SEA LEVEL RISE AND FLOOD RESILIENCY PLAN

Building Resilience and Mitigating Risks on South
Florida Water Resources

Public Comments

(Comment period: June 14, 2022 - July 22, 2022)

Figure 9. Adaptation Pathways map for the entire basin, based on the simulated expected annual damage for the current sea-level and the two possible future sea level rise scenarios.

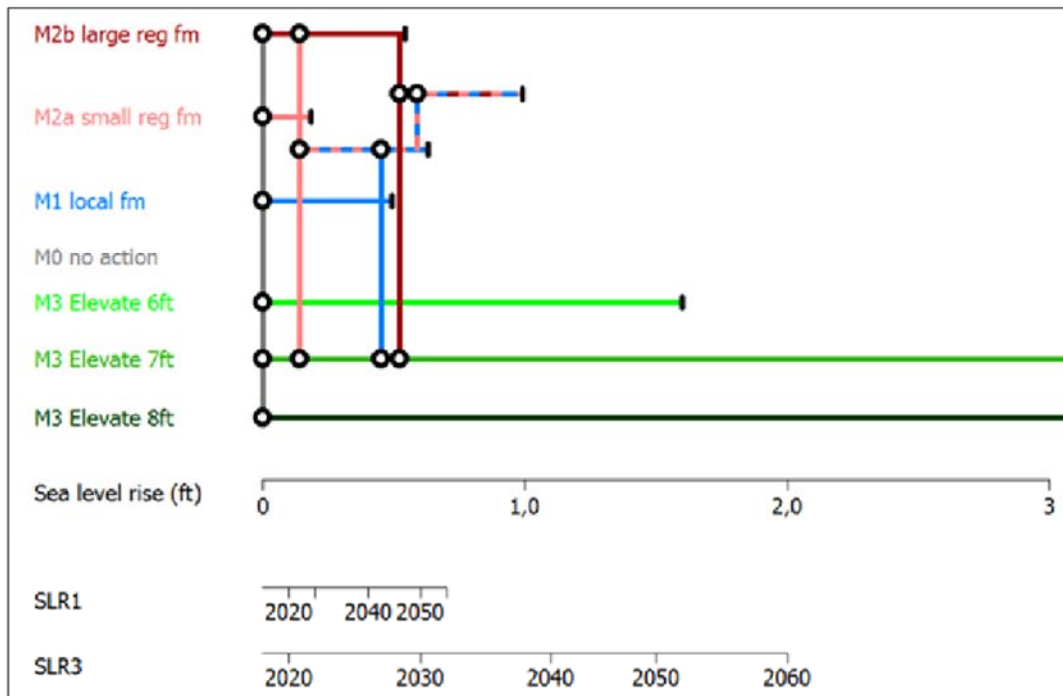
The partnership will be essential to address the larger regional adaptation needs to ensure that multiple flood protection measures are advanced. The excellent work by your agency has shown that expanding pump capacity on the primary canals may be necessary but may not be sufficient to address sea level rise, particularly for coastal areas. In some instances, it may be more effective, enduring, and cost-effective to elevate or floodproof properties. As shown in the C-7 Level of Service assessment, in some instances non-structural flood mitigation measures, such as raising the lowest-lying properties (shown in green below), may have substantially longer efficacy than forward pumps.

Pursuing other flood protection measures in partnership with other entities may also delay or reduce the capacity needed for forward pumps. This would have the benefit of reducing energy and fuel use, reducing water quality impacts, and reducing disruption to wildlife in the canals and bay. While the implementation mechanisms are not yet in place, pursuing flood-proofing measures would also likely reduce the overall adaptation costs. For example, floodproofing all structures in the C-7 below six feet could cost between \$110M and \$220M.¹ It is likely that the most cost-effective approach is an optimized combination of measures. While additional pump capacity may be needed long term, greater emphasis should also be placed on protecting water resources and minimizing negative impacts to Biscayne Bay now. In this regard, additional flood mitigation alternatives should be considered in concert with Miami-Dade County to, among other opportunities, increase storage capacity, divert or otherwise reduce the volume of water conveyed through coastal structures and received by the Outstanding Florida Water body through restoration and infrastructure improvement projects and pilot and implement innovative technologies that improve water quality. This could include identifying opportunities for additional wetlands rehydration projects that can improve wetland habitat and function while

Figure 3. Inland Extent of Saltwater in the Base of the Biscayne Aquifer in South Miami-Dade County⁴

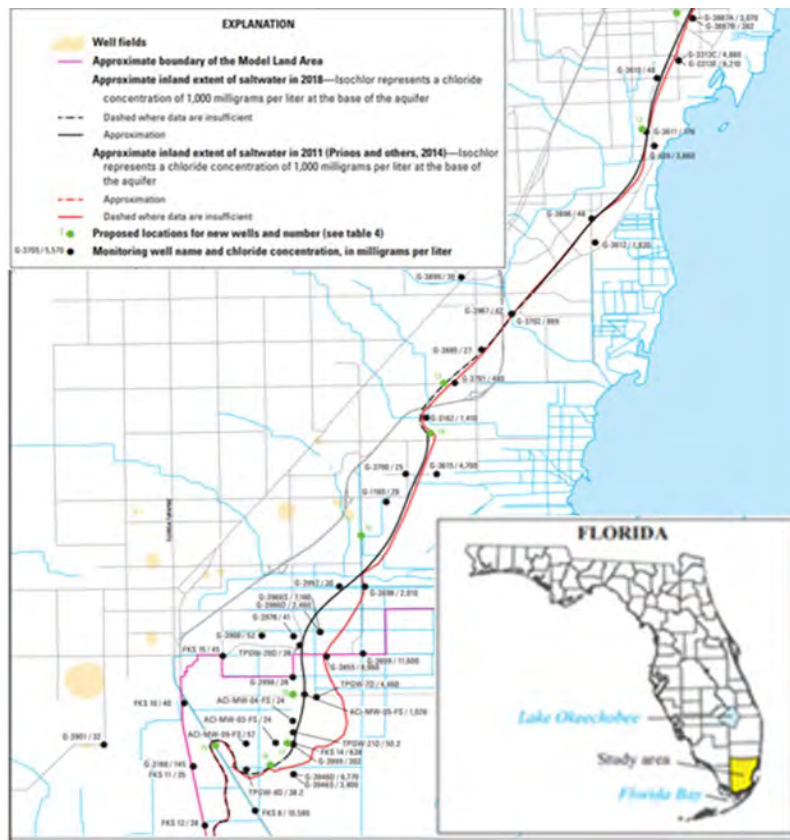
Overall, this plan does not address the diminishing flow of fresh groundwater into Biscayne Bay. In fact, the construction of the curtain wall proposed in this plan will further limit fresh groundwater flow into the bay. It will also limit inflow of water into the Biscayne Aquifer, exacerbating conditions of saltwater intrusion. Figure 3 displays the extent of saltwater intrusion between 2011 and 2018. As indicated in the diagram, the greatest extent of saltwater intrusion is occurring in Southern Miami-Dade County and according to your basic modeling results most of the loss of water flow occurs in that same area. Saltwater intrusion is already occurring and is being exacerbated by other activities such as the seasonal agricultural drawdown and the operations at Turkey Point. A better use of these funds would be to improve our vulnerability to sea-level rise not continue to make us more vulnerable without a plan to fix existing concerns. We understand the benefits of a curtain wall on the water supply of the Taylor Slough and Florida Bay, but the Town cannot support the curtain wall project if it is not made much clearer how the District intends to mitigate for the consequences of this project on Biscayne Bay and Miami Dade County's water supply.

The curtain wall proposal would exacerbate the threat of saltwater intrusion by blocking freshwater recharge from the Groundwater and making the coast more vulnerable. It is questionable whether the use of resiliency funds is appropriate for a curtain wall given it will make Miami Dade County more vulnerable without major mitigation and a clear plan.

Figure 4. Wellfield Protection Areas in Miami-Dade County⁷

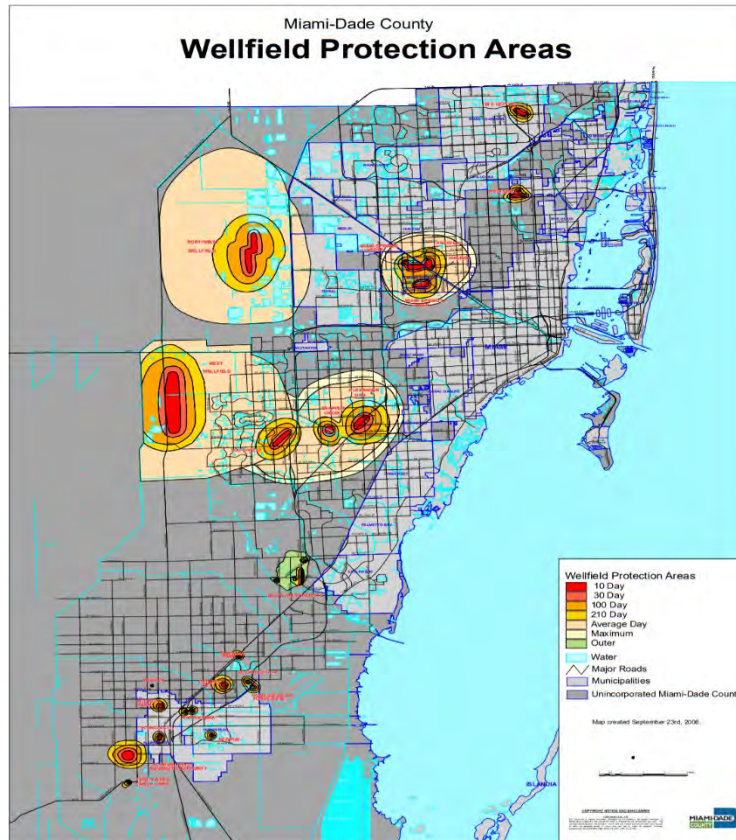
Any one of the three alternative curtain walls would further block the flow of groundwater to the Biscayne Aquifer, reducing wellfield recharge for Miami-Dade's water supply. Figure 4 displays the location of wellfields in Miami-Dade County. Note that these wellfield recharge areas are located east of the proposed curtain wall. We would like more data on the modeling results including all of the assumptions built into the model itself. We would also like to understand the timing of all projects in the area and how these impacts will be mitigated for and how the Town will benefit from this activity.

Figure 1: Maps showing increasing vulnerability of the south C-111 basin and Tylor Slough with sea levels rising from 1 foot to 3 foot (maps were processed online from NOAA's Sea Level Rise viewer).

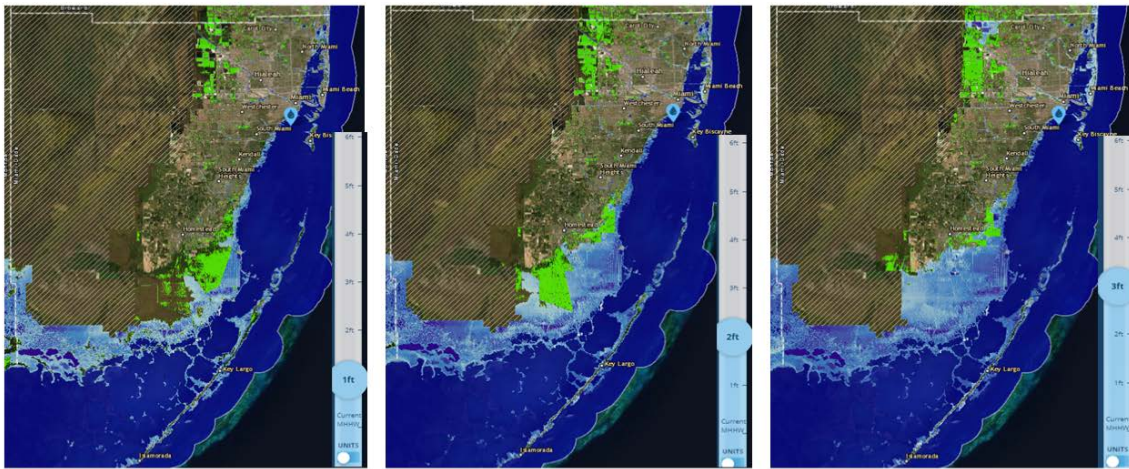
It is encouraging to see integration of ongoing restoration planning efforts to address these challenges in in vulnerable coastal areas of south Florida, such as the Biscayne Bay and Southern Everglades Ecosystem Restoration (BBSSER) Project. It will be important for the District's resilience planning group to work closely with the BBSEER Project Delivery Team as this effort proceeds. An example of a potential disconnect with the BBSSEER planning effort is demonstrated by the proposed enhancement of the L-31E Levee, which is not included in the BBSEER planning effort. Also, the BBSEER eco-sub team is

considering an array of ecological measures and indicators in the C-111 basin, while this draft report plans to incorporate the Everglades Mangrove Migration Assessment (EMMA) Pilot Study in the Model Lands area. It is not clear how these efforts will interface.
